URFO:ROG  
Docket No. 40-6659  
SUA-551, Amendment No. 29  
04006659450E  
04006659451E  
04006659452E  
04006659453E

MEMORANDUM FOR: Docket File No. 40-6659

SUBJECT: AMENDMENT NO. 29 TO SOURCE MATERIAL LICENSE SUA-551 FOR  
RECLAMATION AND CLOSURE OF PETROTOMICS URANIUM MILL IN  
SHIRLEY BASIN, WYOMING

Figure 1

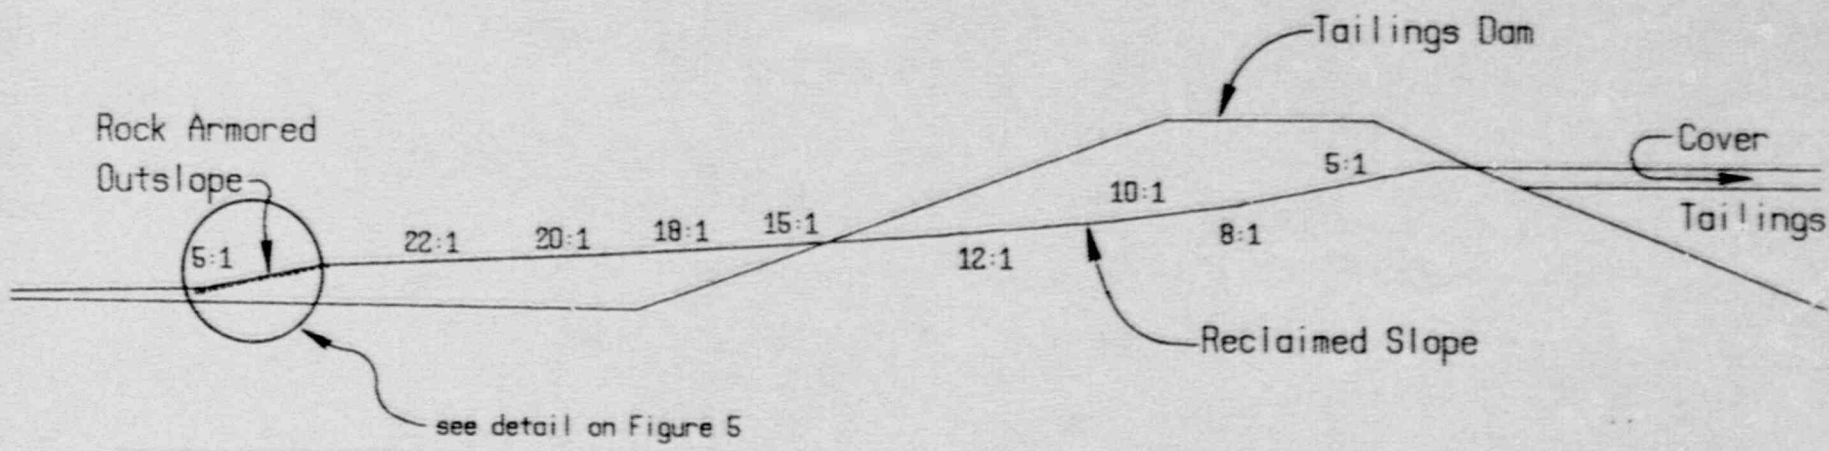
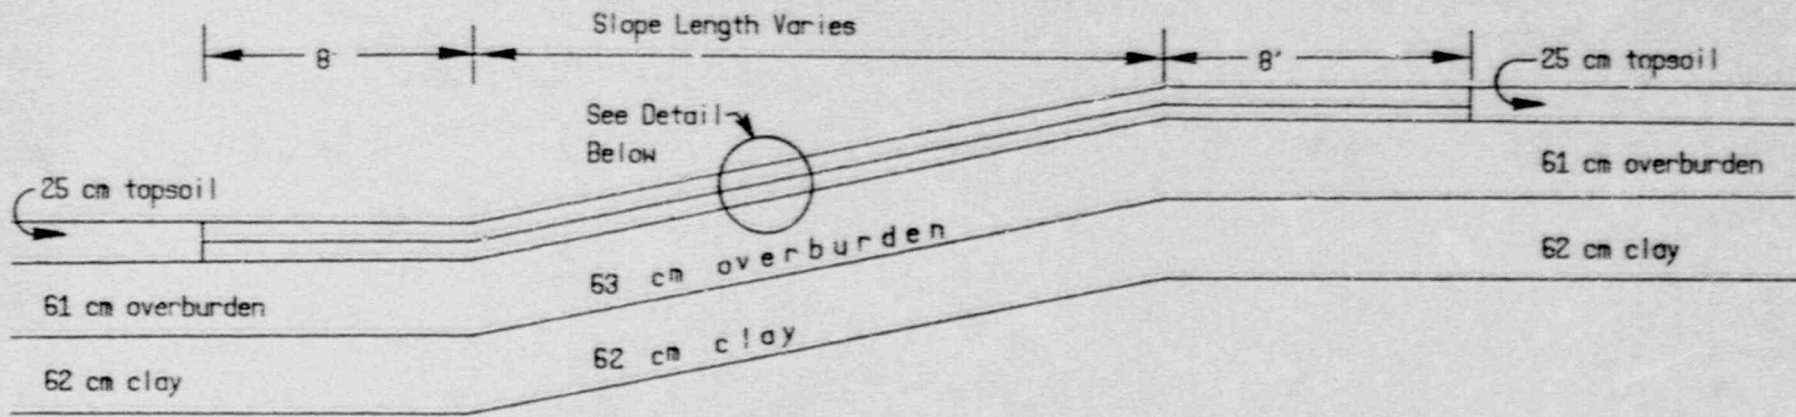
Petrotomics' reclamation plan consists of stabilizing the tailings in place (Figure 1). All of the tailings solution has been evaporated from the impoundment area. The small amount of water that remains is recovered seepage water which is being removed by evaporation.

As shown in Figure 1, the pile top has been designed with two drainage swales, the North Swale and the South Swale, which will convey runoff from the pile top to two riprapped swale discharge channels. The North Swale Discharge Channel will then convey flow to the North Channel and the South Swale Discharge Channel will convey flow to an area south of the tailings pile. The reclamation plan will also incorporate several diversion channels to intercept and divert runoff away from the tailings pile. Two channels, the West Dump Channel and the East Dump Channel, will divert runoff from an area to the north. South of these two channels, there is a third channel, the North Channel, which will convey runoff from a small intervening area north of the pile and from a portion of the pile top. A fourth channel, the Southwest Channel will drain an area to the south and west of the pile. The North and Southwest Channels will merge in a riprapped structure at the western edge of the reclamation area.

As shown in Figure 1, the North Channel will carry runoff from the North Swale on the tailings pile and from a drainage area of about 200 acres. The total drainage area is about 256 acres. In general, the channel side slopes will be 200H:1V on the left side and 50H:1V on the right side. In addition, the channel will have a 0.5 foot deep low-flow section with a 40-foot bottom width and 5H:1V side slopes. The upstream end of the channel will have a triangular cross section with 50H:1V side slopes. The downstream end will be trapezoidal in cross section with 3.5H:1V side slopes and will be armored with a 1.9-foot

As shown in Figure 1, the North and Southwest Channels will converge into one channel west of the tailings pile. This confluence will be protected with a 1.9-foot thick layer of riprap having a median stone diameter ( $D_{50}$ ) of 1.1 feet. The riprap will be placed over a 6-inch thick filter layer which will be underlain by 6 inches of coarse sand. As shown in Figure C.2-5 of the June 30, 1988 submittal, the riprap will be extended 170 feet upstream from the confluence along the North Channel and about 770 feet along the Southwest Channel. Downstream from the confluence, the riprap will be extended about 390 feet. At the outlet of the channel, the riprap will be extended 6 feet below the channel bottom to prevent excessive scour and potential headcutting. Details of the design of the outlet are presented in Figure C.2-5 of the June 30, 1988 submittal.

#### Pile Top

As shown on Figure 1, the pile top will consist of an upper level and a lower level. The slopes of these areas have been designed for no erosion using the Horton equation discussed in the Draft Staff Technical Position (Reference 19). The upper level will be crowned so that runoff will flow radially off the pile. This level will be 16 to 20 feet higher than the lower level. A minor portion of the runoff from the upper level will flow into a closed basin located east of the tailings. The majority of the runoff from the upper level will flow down a 5H:1V slope, then onto the lower level. The 5H:1V slope will be protected with a 5.75-inch thick layer of riprap having a  $D_{50}$  of 3.3 inches. This riprap will be placed on a 4-inch thick filter blanket (Figure 3). The riprap at the upper end of the 5H:1V slope will be extended 8 feet onto the upper level. At the toe of the 5H:1V slope, the riprap will also be extended 8 feet onto the flatter lower level to provide an apron for dissipating the energy of the flowing water (Figure 3).

Runoff from the pile top will flow into two broad and gently sloping swales (Figure 1). Each of these swales will convey flow from the tailings cover to a riprapped channel. These channels are described as the North Swale Discharge Channel and the South Swale Discharge Channel. The design of these channels is as shown on Figure C.2-3 of the licensee's June 30, 1988 submittal.

Figure 3

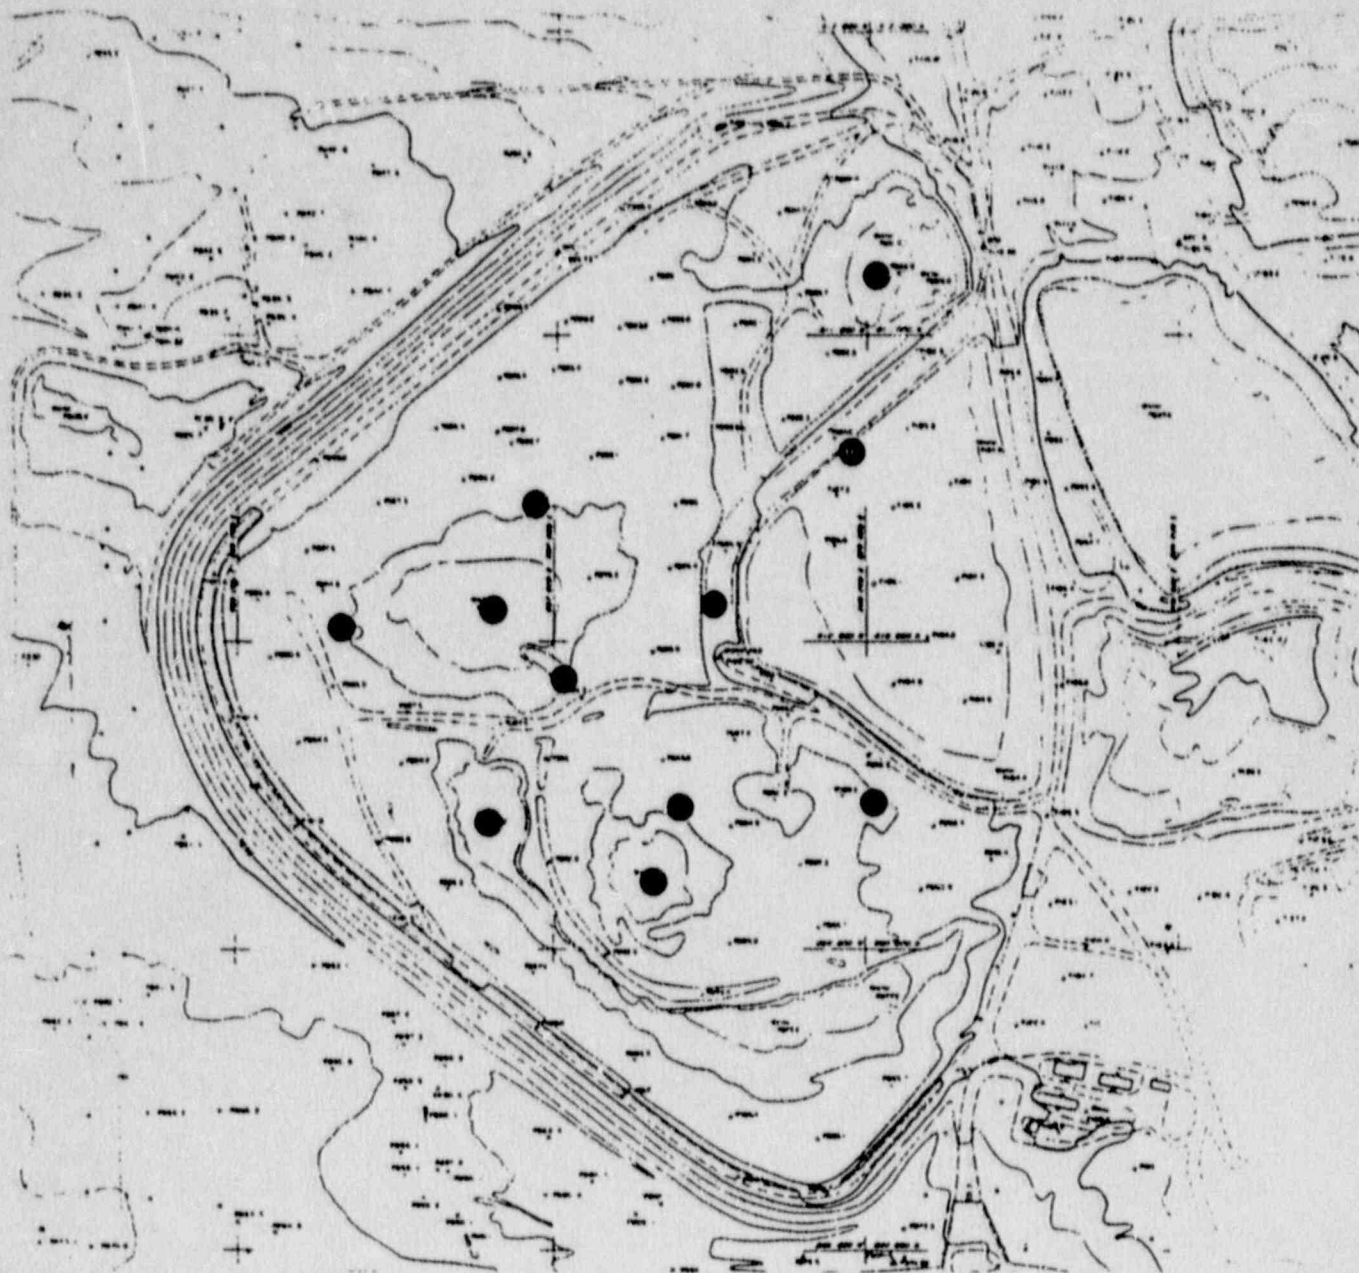
The adequacy of extending the riprap 8 feet at the top and toe of the 5H:1V slope was independently checked. At the top of the slope, the velocity and shear stress during a PMP event would be about 1.9 feet per second (fps) and 0.14 pounds per square foot (psf), respectively. At the toe, the velocity would be about 1.6 fps and shear stress about 0.09 psf. These values are considered to be less than the allowable for the soil being used. Therefore, extending the riprap 8 feet at the top and toe of the 5H:1V slope on the pile top is acceptable.

Figure 4

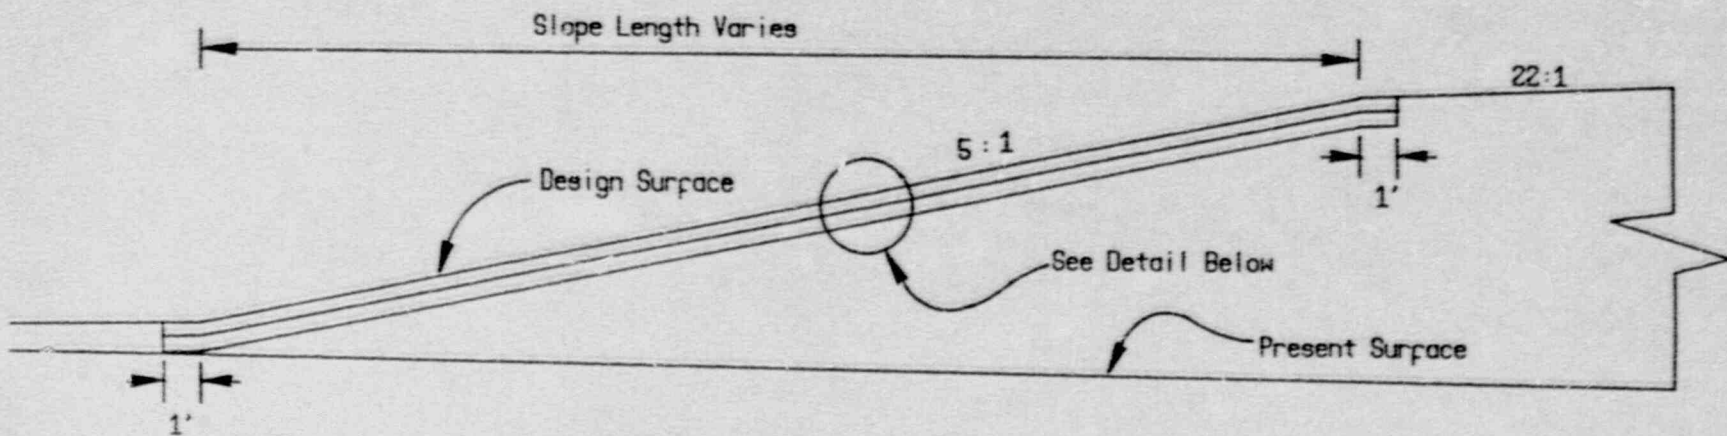
Eleven settlement monitoring stations will be established at the approximate locations shown on Figure 4. Monuments will consist of steel bars welded to steel plates that will be embedded in concrete. These monuments will be monitored as shown in Table 2 until 90 percent consolidation has been reached. When primary settlement is complete at all the monitoring stations as defined in Reference 8, and the enhanced evaporation effort is complete, the clay cover
